ADDENDUM NO. 4

January 30, 2023

Three Rivers Community Schools – Three Rivers Middle School Additions and Renovation

This Addendum consists of Pages ADD 4-1 through ADD 4 - 3, Attached RFI Log, Substitution Request, and GMB Architecture and Engineering Addendum No. 4, dated January 26, 2023, consisting of 4 pages, Reissued Specification Sections; 08 71 00 – Door Hardware, 09 22 16 – Non-Structural Metal Framing, and 09 65 19 - Resilient Tile Flooring, New Sheet; S3.1E, and Reissued Sheets; G0.00, G1.01, G2.01, C8.01, A1.1E, A2.1E, A2.30, A5.01, A6.01, A7.03, A8.01, A8.02, M1.1D, M1.1E, M1.81, M2.1C, M2.1D, M2.1E, M3.1D, M8.01, M8.03, M8.04, M9.01, M9.02, E1.1C, E1.1D, E2.1D, E2.1E, and E7.01.

3 AHU-23.2 CONTROL DIAGRAM
M8.03 NOT TO SCALE

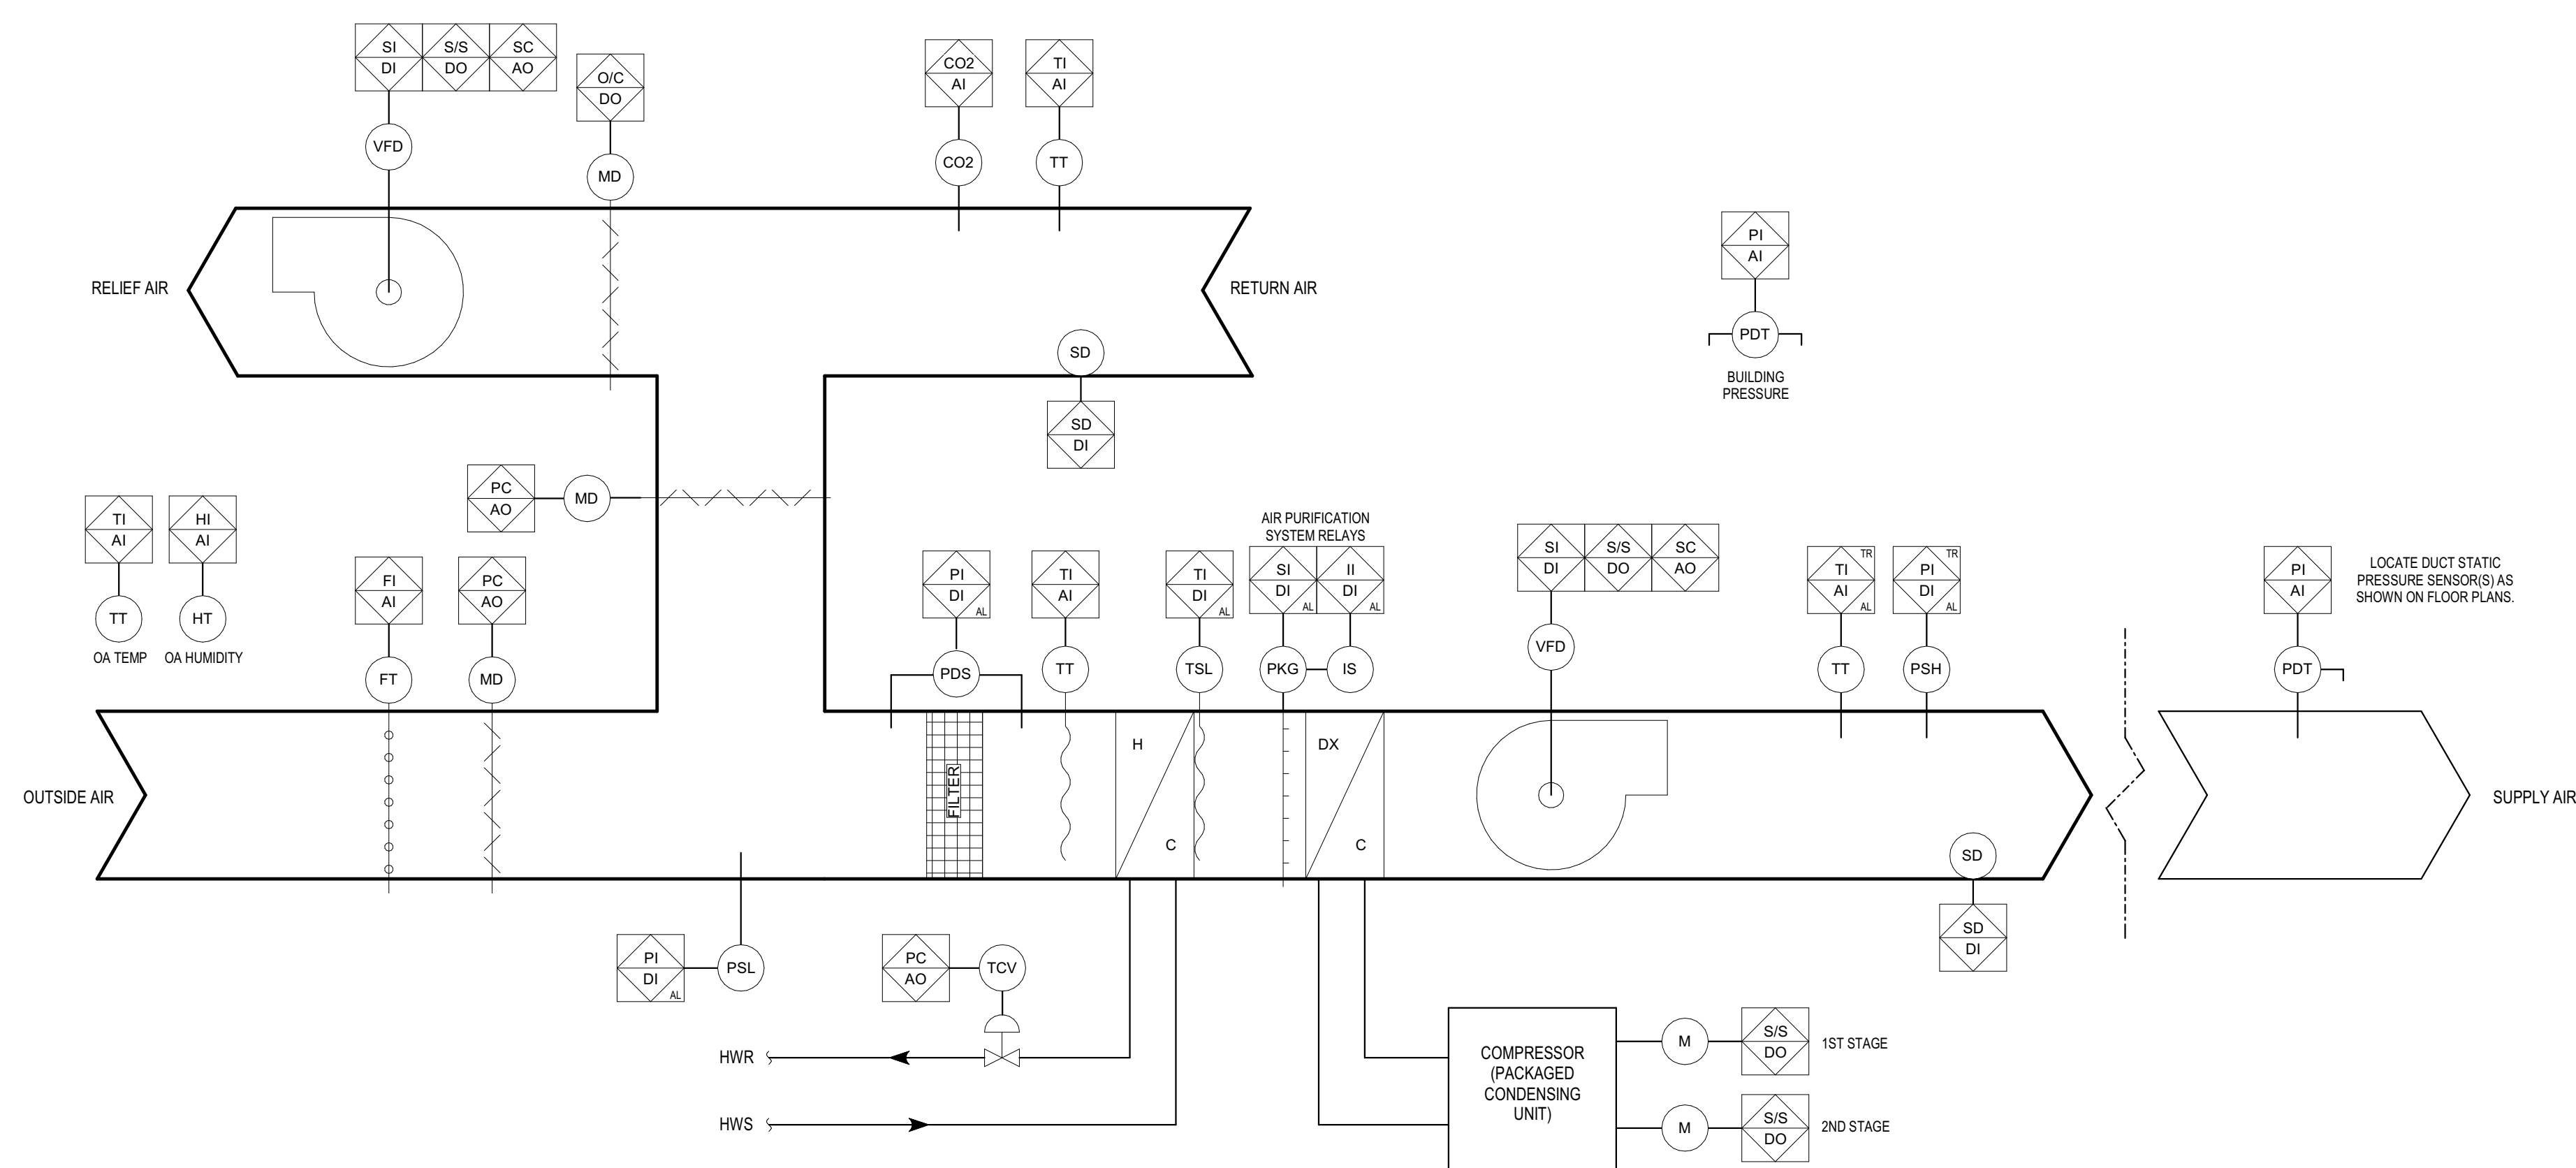
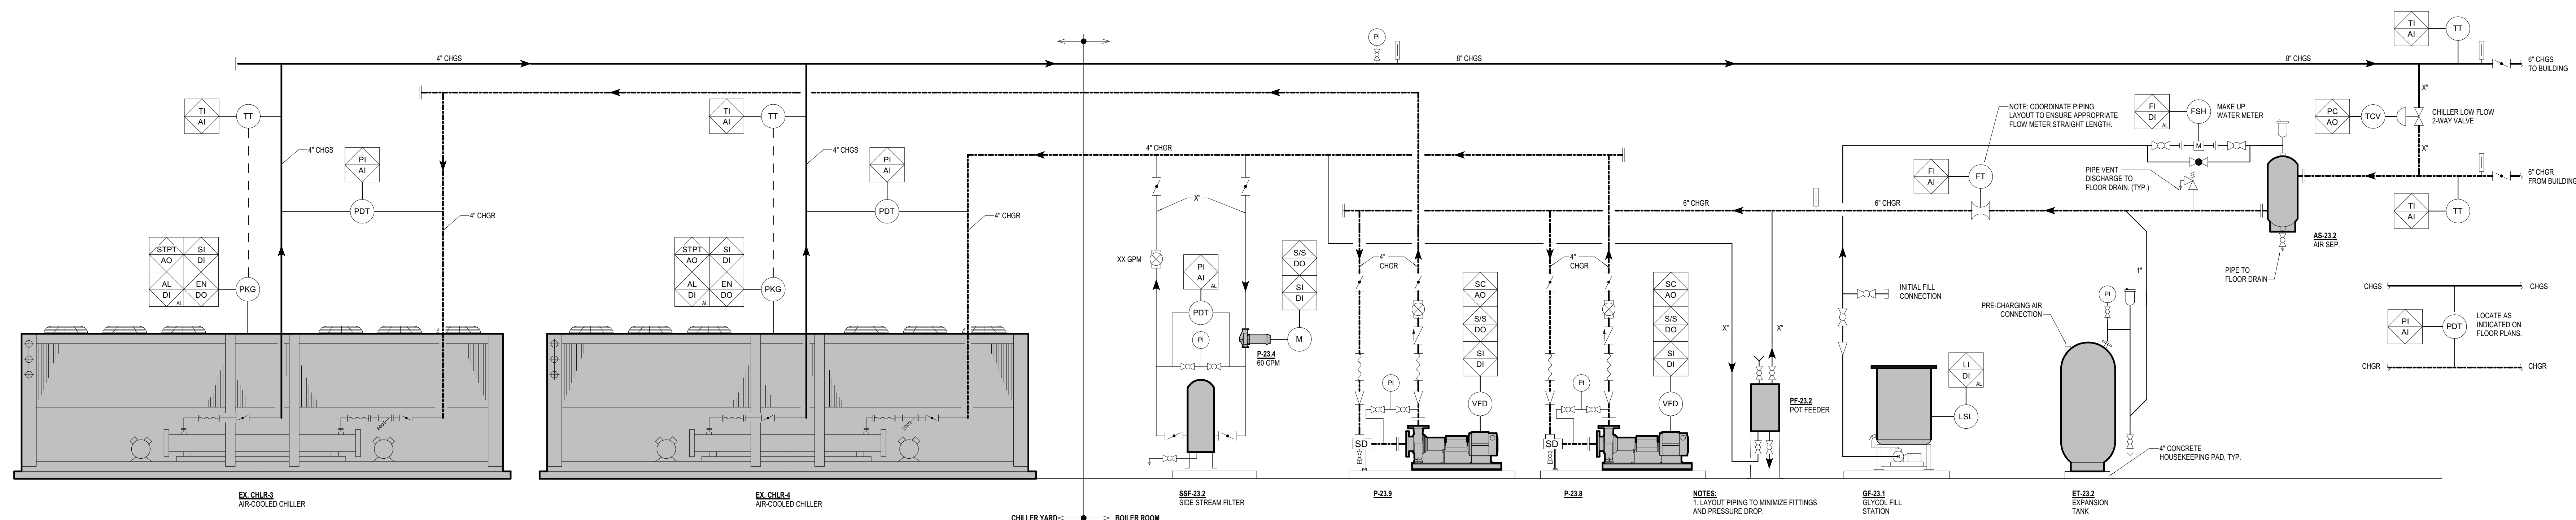
Added note to designate that the chilled glycol system equipment controls are included under Alternate M-1 work.

UNIT 'D' FIRST FLOOR ELECTRICAL DEMOLITION PLAN
1/8" = 1'-0"

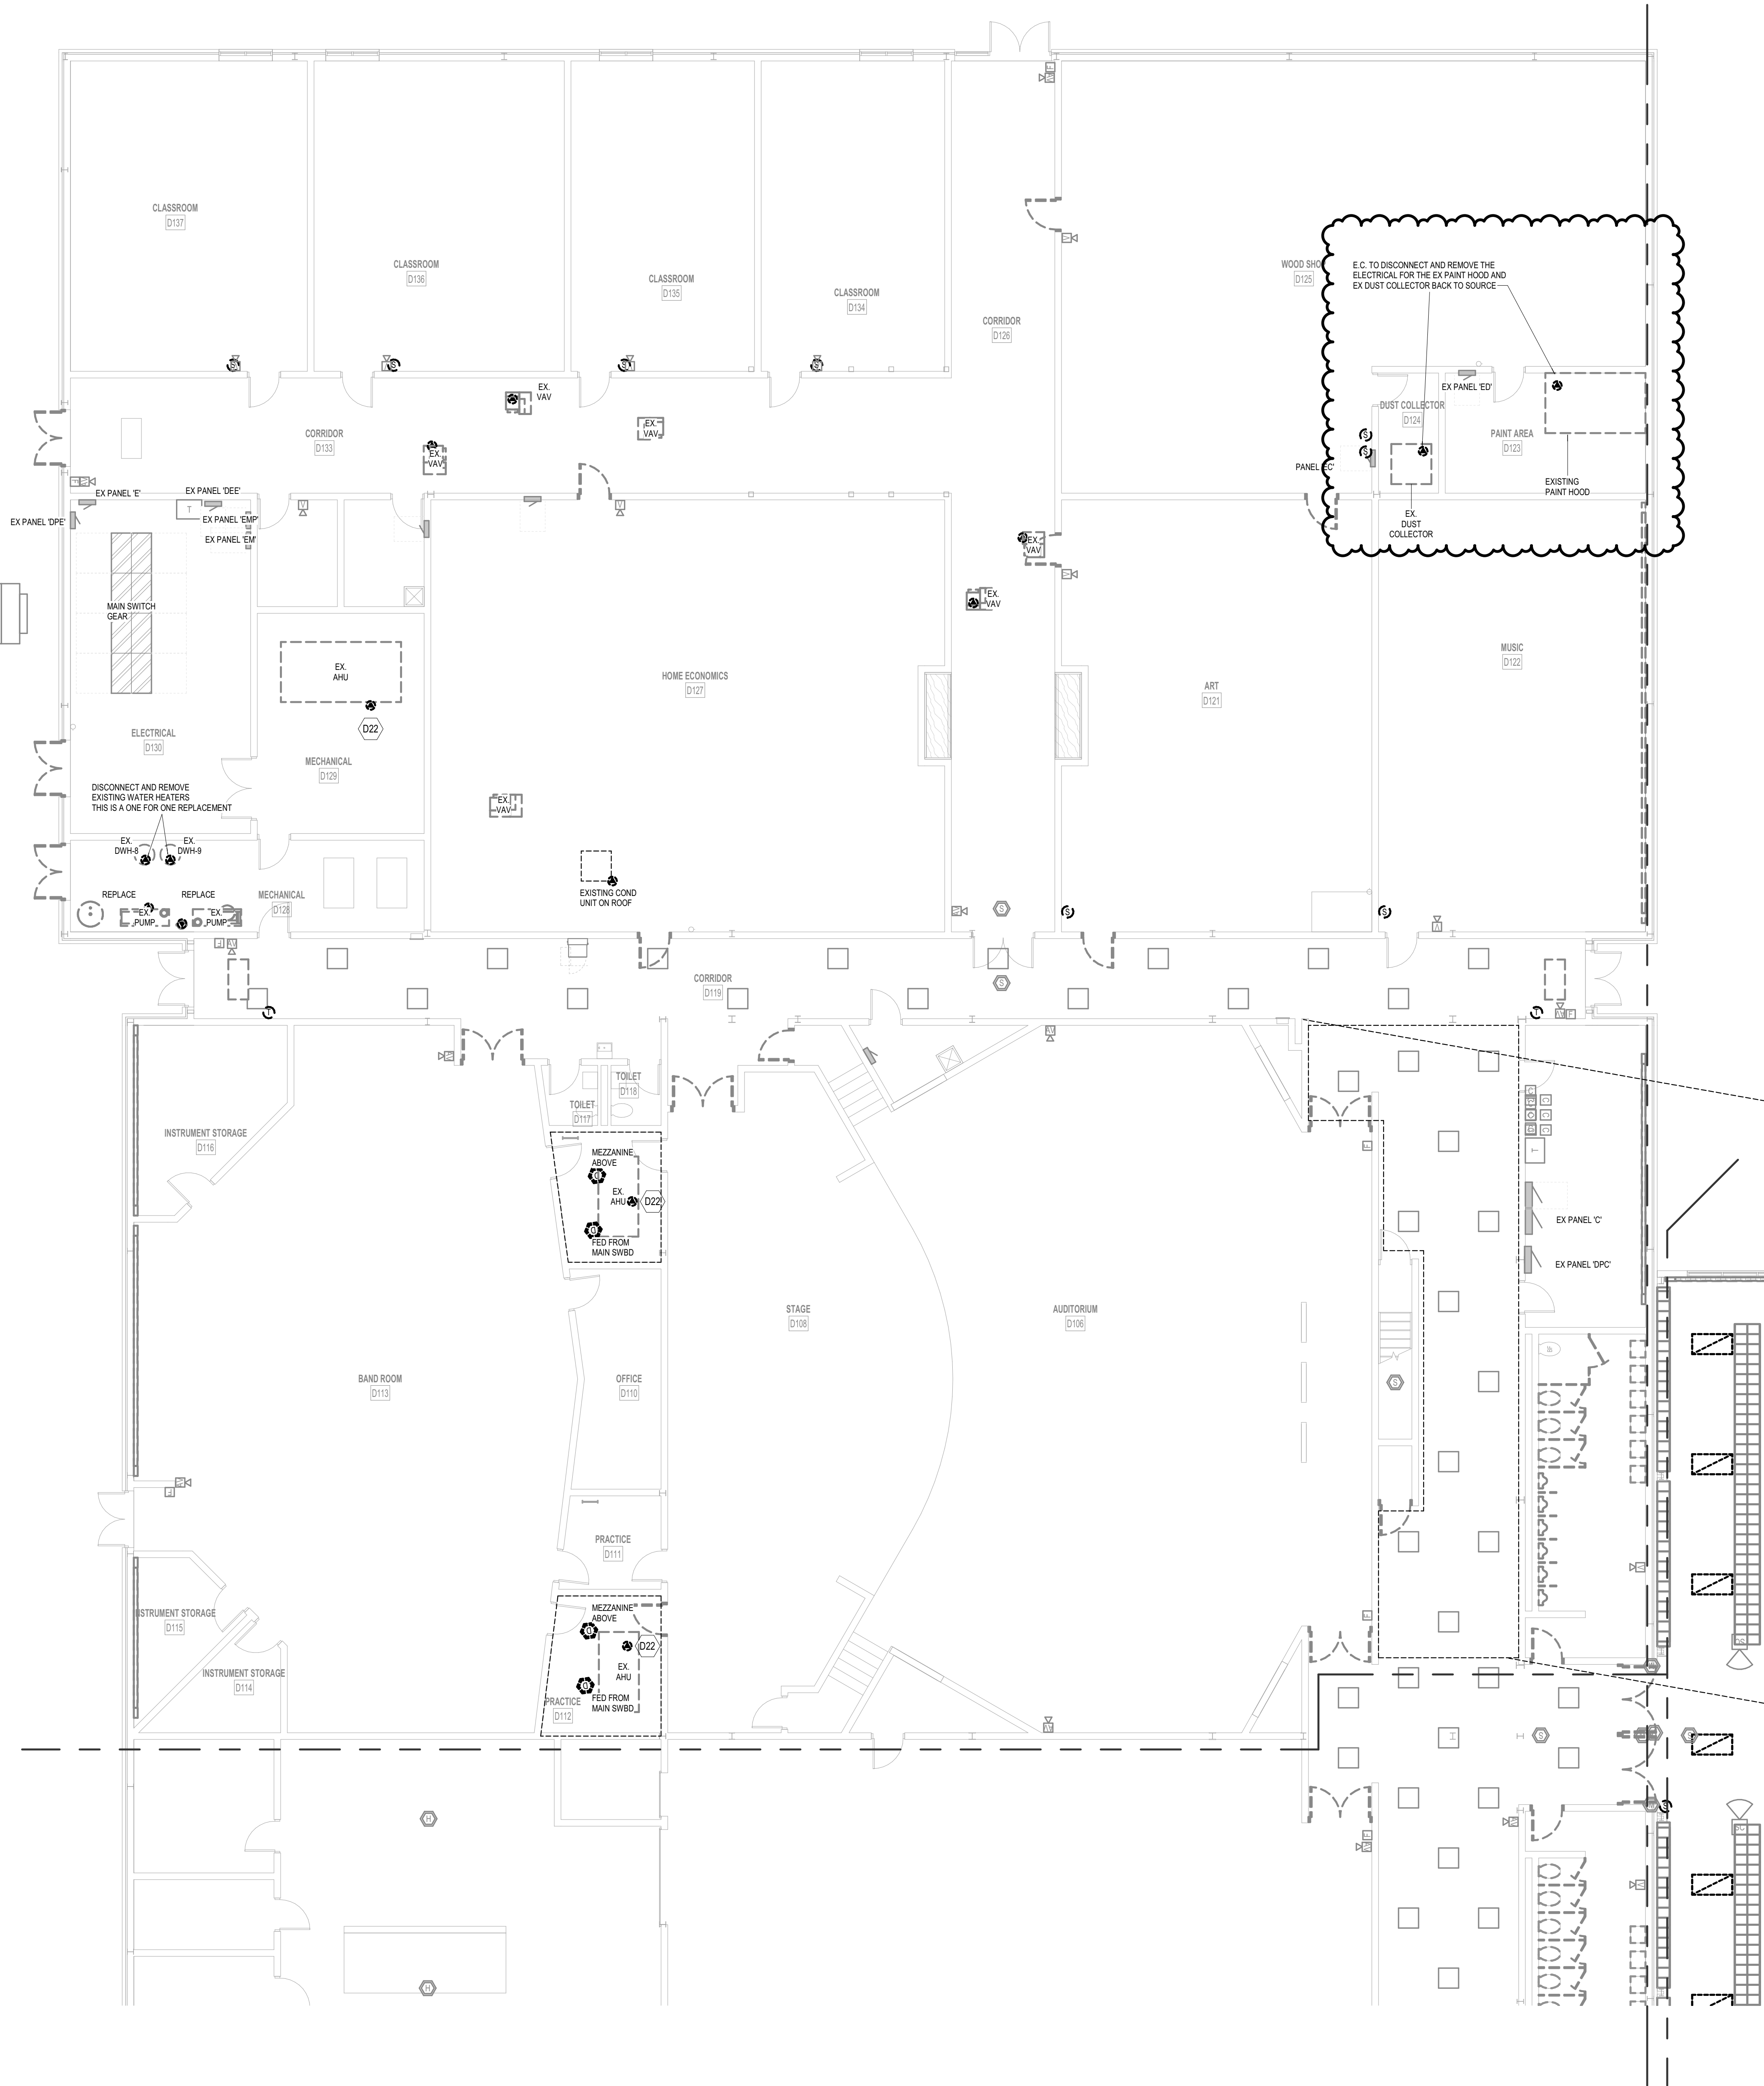
Refer to the plan for the disconnection and removal of the electrical for the existing paint hood and dust collector.
